Joseph M. Farley Nuclear Plant – Units 1 and 2  
Vogtle Electric Generating Plant – Units 1 and 2  
License Amendment Request to Revise Technical Specification  
Surveillance Requirement 3.1.3.2 and Specification 5.6.5

**Joseph M. Farley Nuclear Plant – Units 1 and 2  
Vogtle Electric Generating Plant – Units 1 and 2  
License Amendment Request to Revise Technical Specification  
Surveillance Requirement 3.1.3.2 and Specification 5.6.5**

**FNP and VEGP Basis for Proposed Change**

**FNP Technical Specifications and Bases Markup Pages**

**Figure 5**  
**Predicted HFP 300 ppm MTC vs Cycle X Burnup**

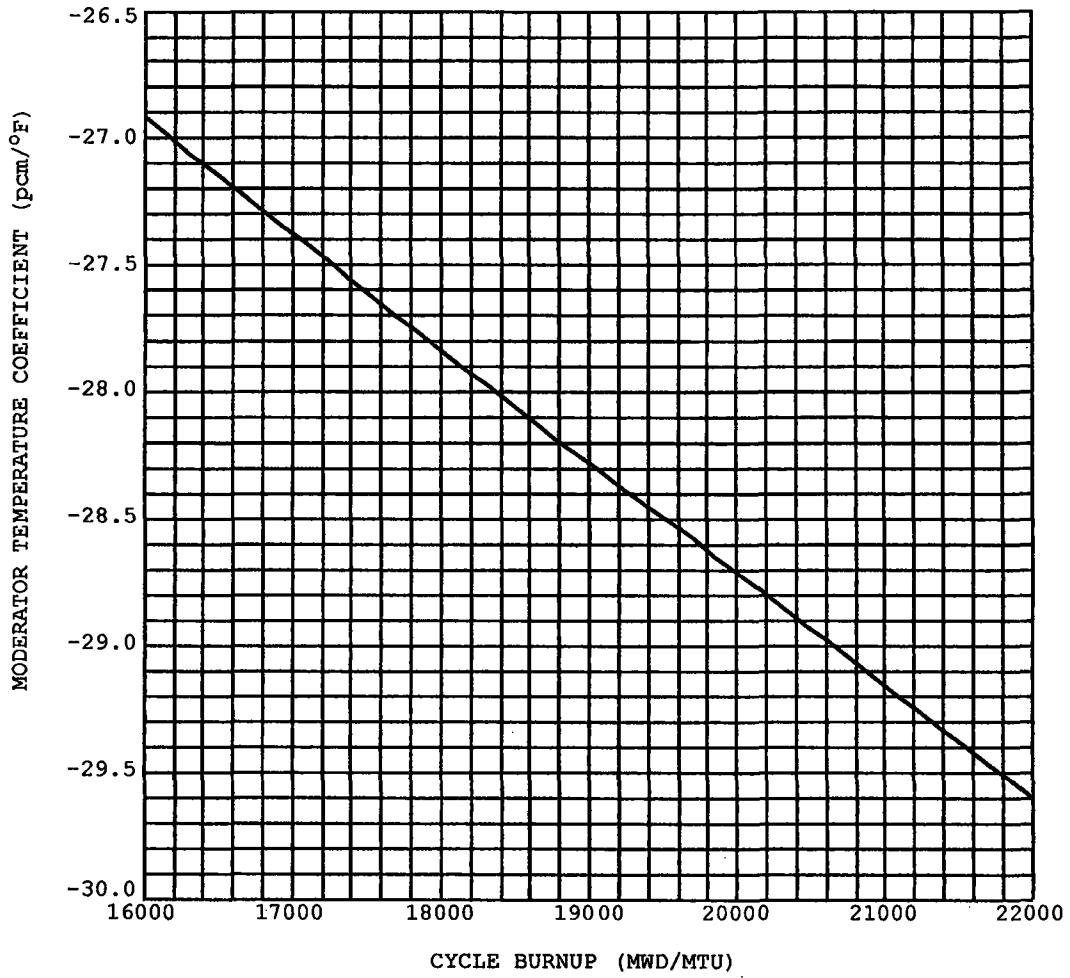
The Revised Predicted 300 ppm MTC shall be calculated using Figure 5 and the following algorithm:

Revised Predicted MTC = Predicted MTC + AFD Correction - Predictive Correction

If all of the benchmark data contained in the surveillance procedure are met and the Revised Predicted MTC satisfies the surveillance limit, then an MTC measurement in accordance with SR 3.1.3.2 is not required to be performed.

**Figure 6**  
**Predicted HFP 300 ppm MTC vs Cycle X Burnup**

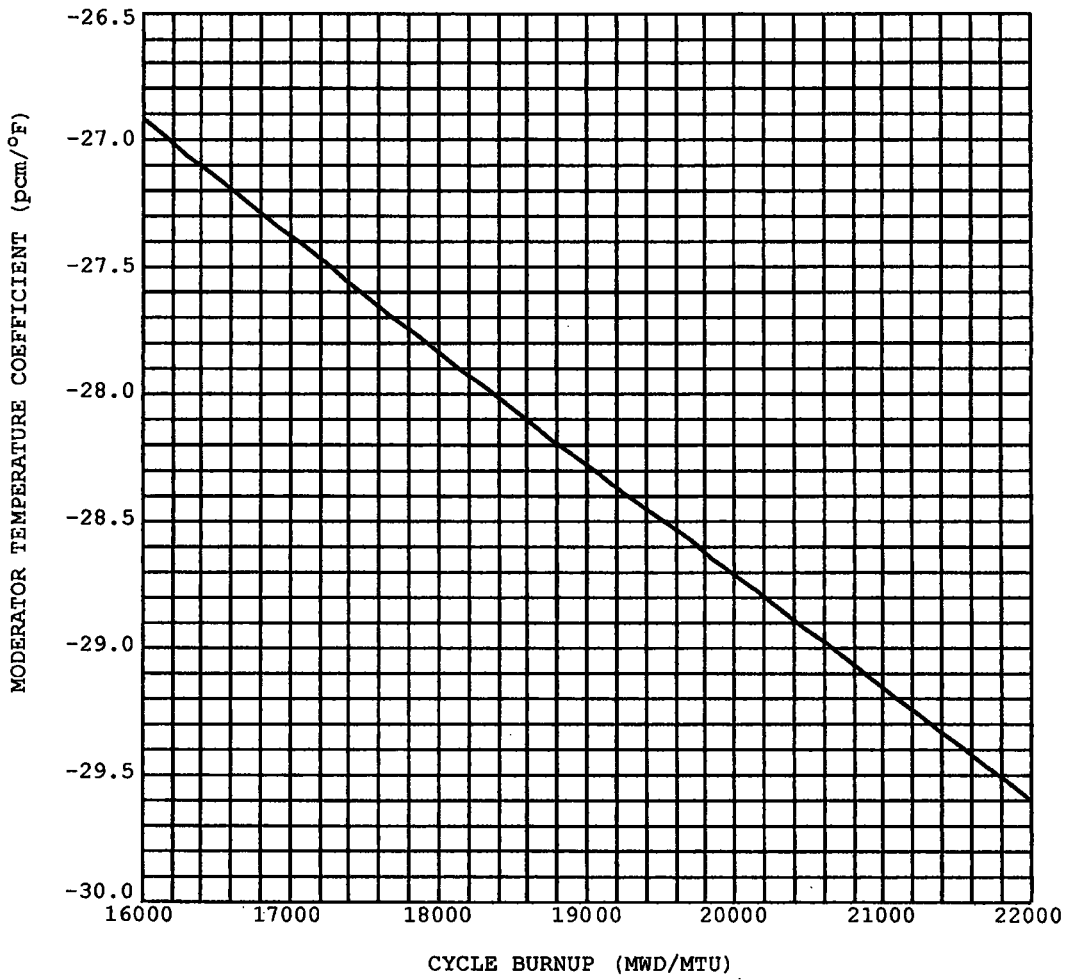
The Revised Predicted 300 ppm MTC shall be calculated using Figure 6 and the following algorithm:

Revised Predicted MTC = Predicted MTC + AFD Correction - Predictive Correction

If all of the benchmark data contained in the surveillance procedure are met and the Revised Predicted MTC satisfies the surveillance limit, then an MTC measurement in accordance with SR 3.1.3.2 is not required to be performed.
